Technical Bulletin 91

6400/6700 Pipe Mounting Bracket Notice

Version 1.0, Revision AA (24 March 2000)

Normal Installation of Pipe Mounting Brackets

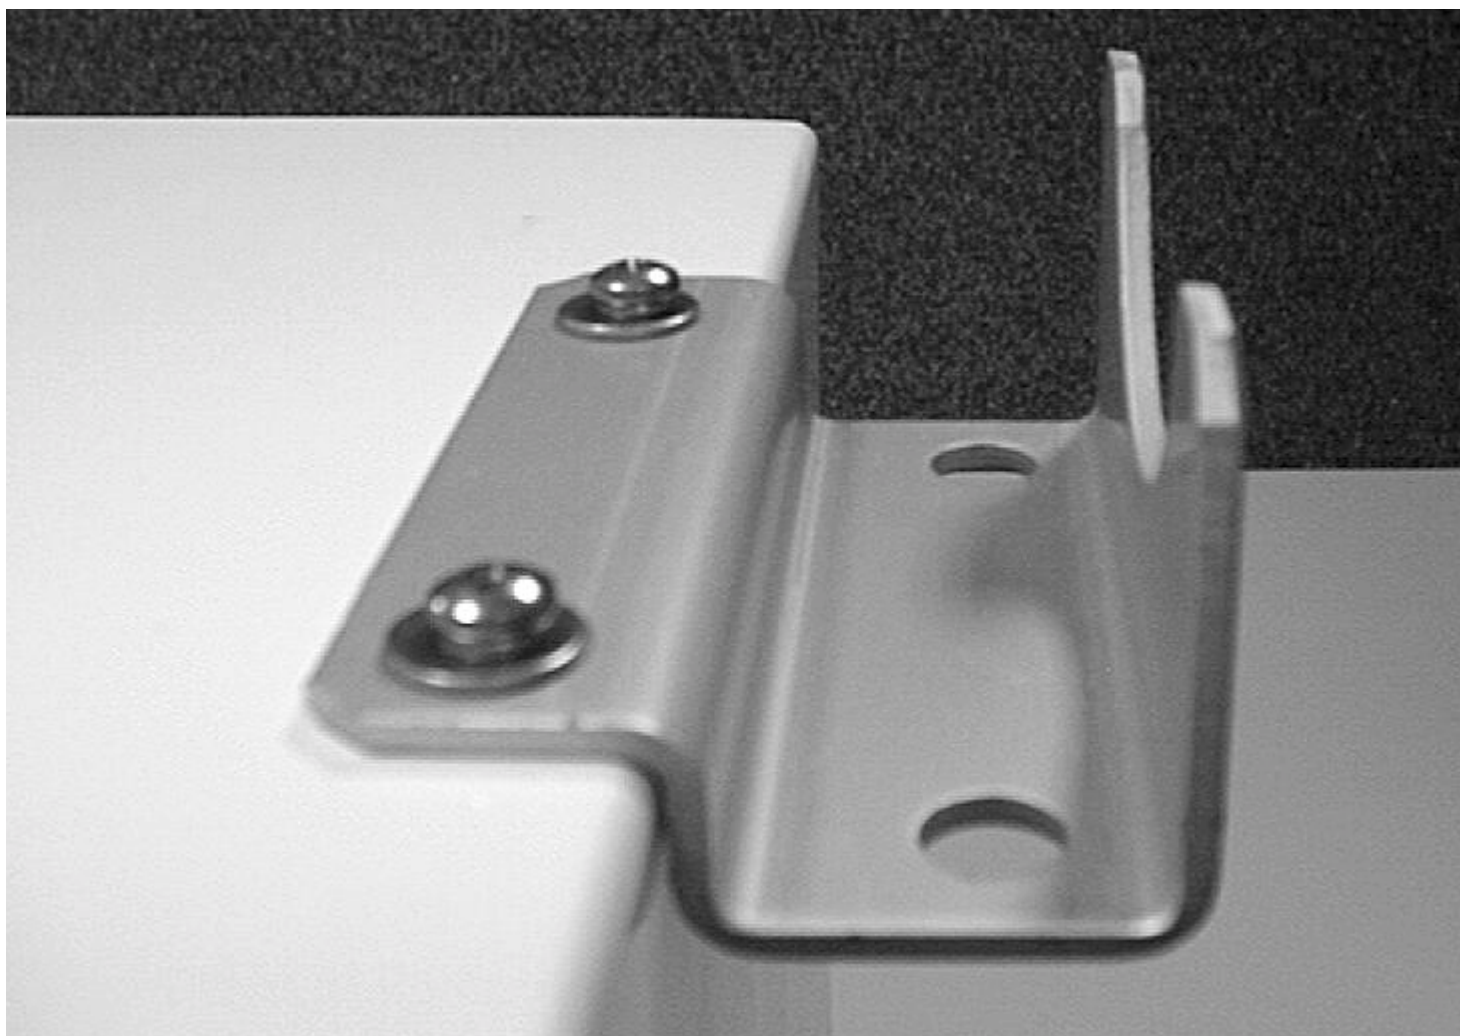
1. **Purpose:** To alert customers of a manufacturing defect of the pipe mounting brackets that attach to the 6400 and 6700 enclosures.
2. **Description:** Approximately 800 pipe mounting brackets were received by Totalflow and shipped in 400 units of 6400 or 6700 enclosures. The brackets in question had the enclosure mounting holes and the U-Clamp pipe mounting holes reversed.

Alternate Installation of Incorrect Pipe Mounting Brackets

3. **Conclusion:** The bracket can be used "as is" by rotating the bracket 180 degrees from the direction depicted on the installation drawing. See attached pictures. If this is unsuitable for customer use, please contact Totalflow Parts and new brackets will shipped.
